NO.	DATE	ISSUED FOR	BY
2	03/02/2020	ADDENDUM	GAB
1	01/21/2020	BID SET	GAB

CITY OF HALLANDALE BEACH UTILITIES DEPARTMENT
PRODUCTION WELL PW-9
STAGING PLAN

CITY OF HALLANDALE BEACH UTILITIES DEPARTMENT
PRODUCTION WELL PW-9
ENLARGED STAGING PLAN

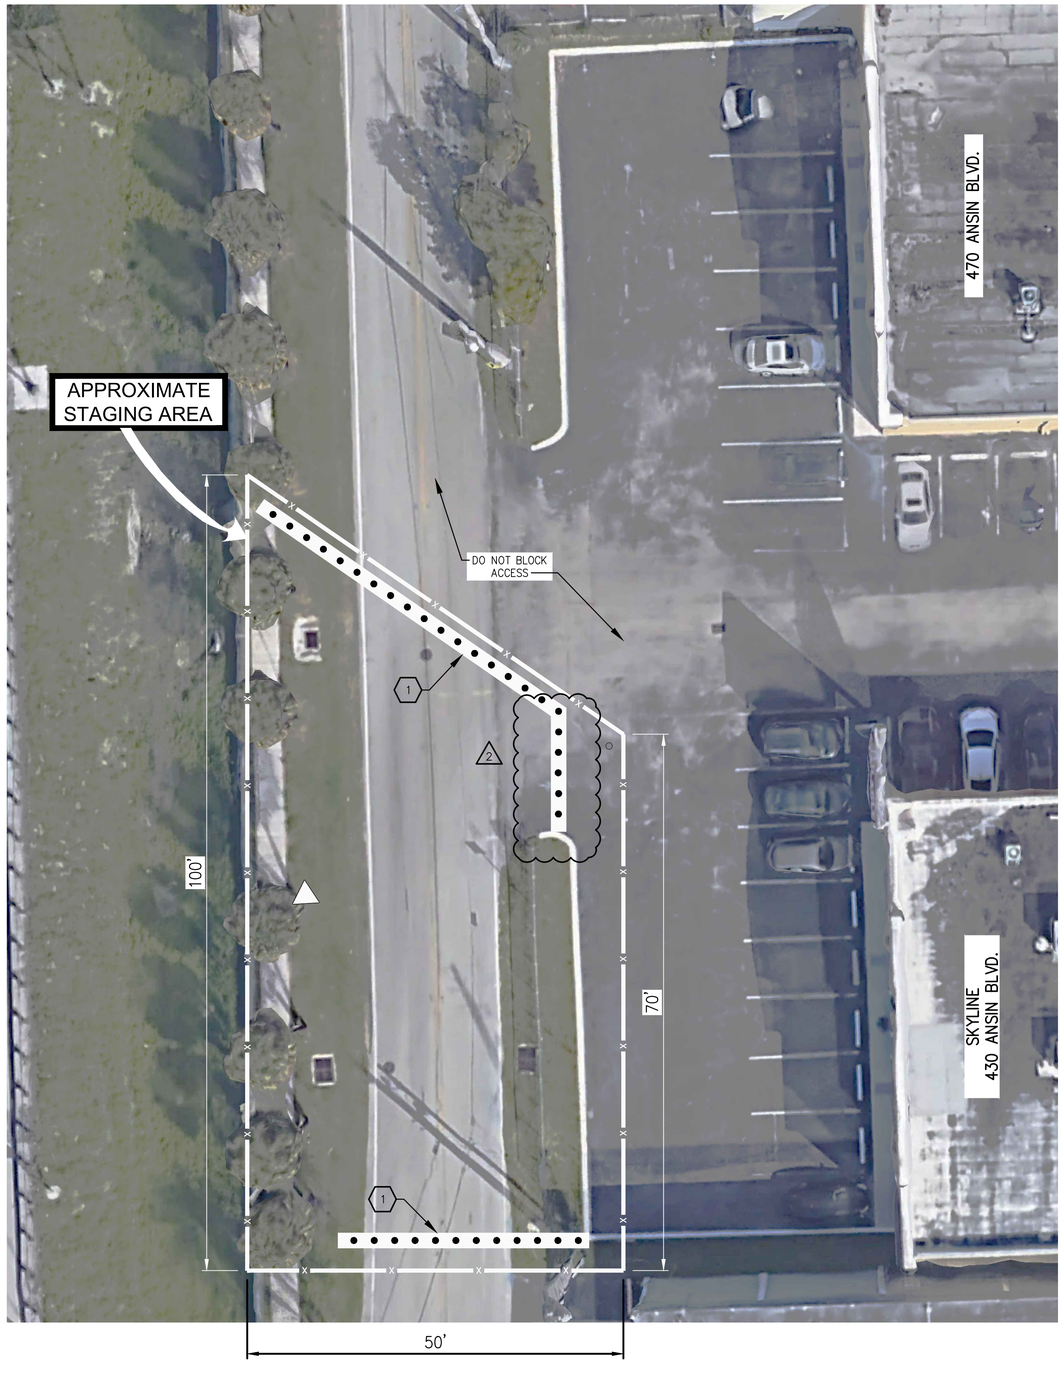
1. IT IS THE ENGINEER-OF-RECORD'S DESIGN INTENT THAT THE TRAFFIC BARRIERS SHOWN ON THIS DRAWING BE LEFT IN PLACE CONTINUOUSLY DURING THE WELL DRILLING PHASE AND OTHER CONSTRUCTION PHASES AS DEEMED NECESSARY BY THE CONTRACTOR.

2. LEAVING THE BARRIERS IN PLACE FOR AN EXTENDED DURATION WILL RESULT IN CLOSING THE ROAD (AND SIDEWALK) IN THE VICINITY OF THE CONSTRUCTION SITE FROM VEHICLE AND PEDESTRIAN TRAFFIC.

3. THE CONTRACTOR SHALL SUBMIT A TRAFFIC CONTROL PLAN TO THE CITY OF HALLANDALE BEACH ENGINEERING DIVISION IN ACCORDANCE WITH TECHNICAL SPECIFICATION 01570.

4. THE CONTRACTOR'S TRAFFIC CONTROL PLAN SHALL REQUEST PERMISSION TO LEAVE THE TRAFFIC BARRIERS IN PLACE FOR AN EXTENDED DURATION.
5. THE TRAFFIC CONTROL PLAN SHALL DEFINE DETOUR REQUIREMENTS (SEE TECHNICAL SPECIFICATION 01570) TO ENSURE THAT VEHICLES AND PEDESTRIANS CAN REACH BUSINESSES ON EITHER SIDE OF THE REQUESTED TEMPORARY ROAD CLOSURE.

1 FURNISH AND INSTALL PLASTIC WATER FILLED BARRIER.

PROPOSED SANITARY SEWER REPLACEMENT PLAN

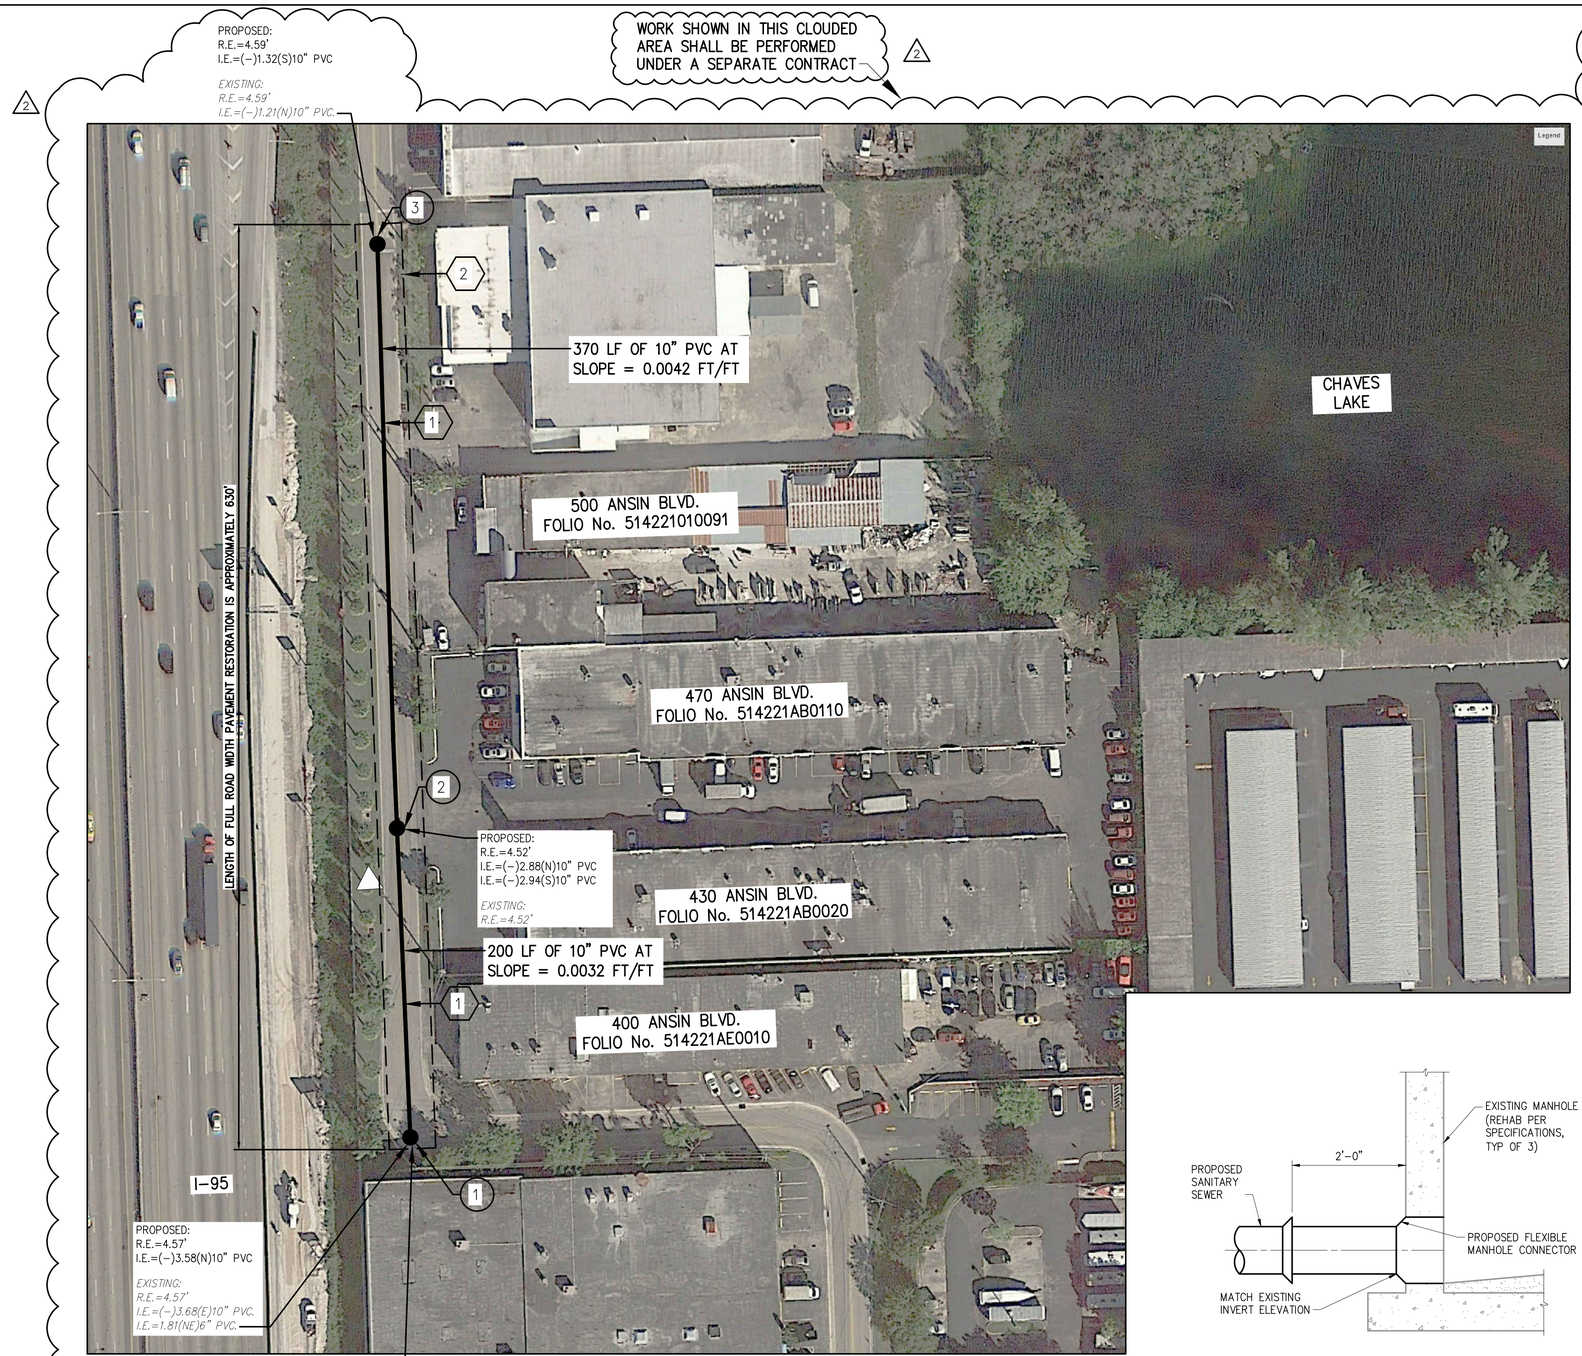
WORK SHOWN IN THIS CLOUDED AREA SHALL BE PERFORMED UNDER A SEPARATE CONTRACT

WELLHEAD DISCHARGE
DETAIL 2
1 1/2" = 1'-0" M-01

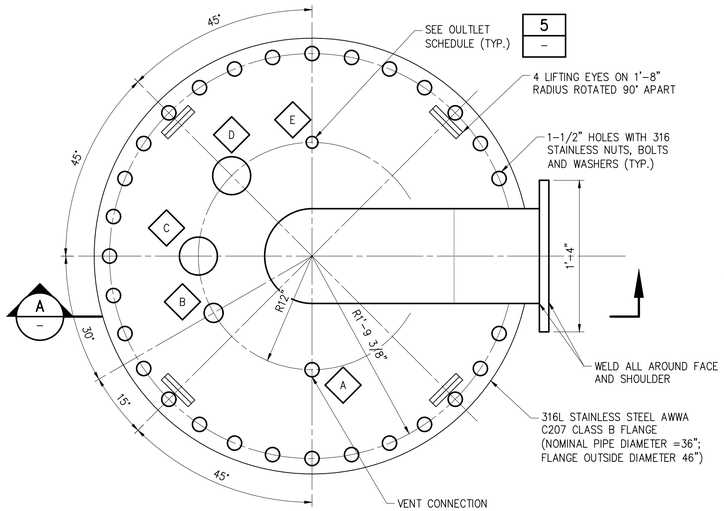
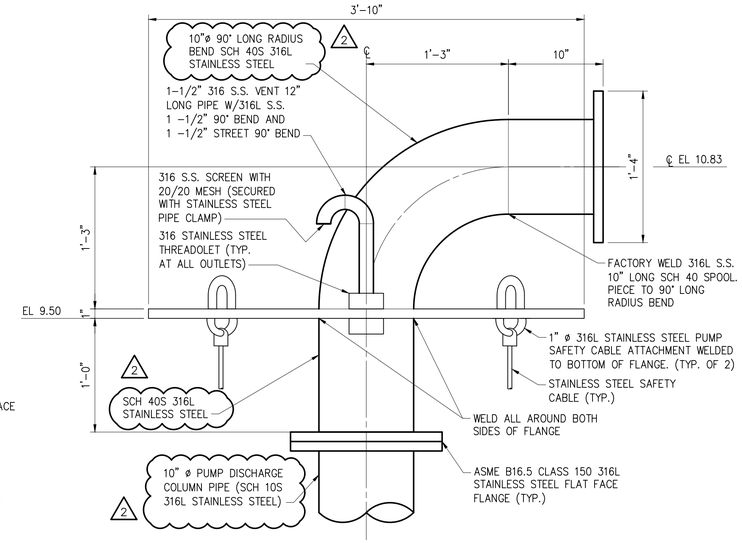
1. ALL MATERIAL SHALL BE ASTM A240 AND/OR ASTM A403 316L STAINLESS STEEL. WELLHEAD FABRICATION SHALL BE PICKLED AND PASSIVATED PER ASTM A380. THE WELLHEAD SHALL HAVE A UNIFORM 2D FINISH.
2. ~~PIPE AND NIPPLES SHALL BE SCHEDULE 40S.~~ NOT USED
3. WELDERS SHALL BE CERTIFIED BY THE AMERICAN WELDING SOCIETY.
4. ALL OUTLES SHALL HAVE THREADOLETS ABOVE AND BELOW THE FLANGE.
5. FURNISH AND INSTALL NEOPRENE GASKET.
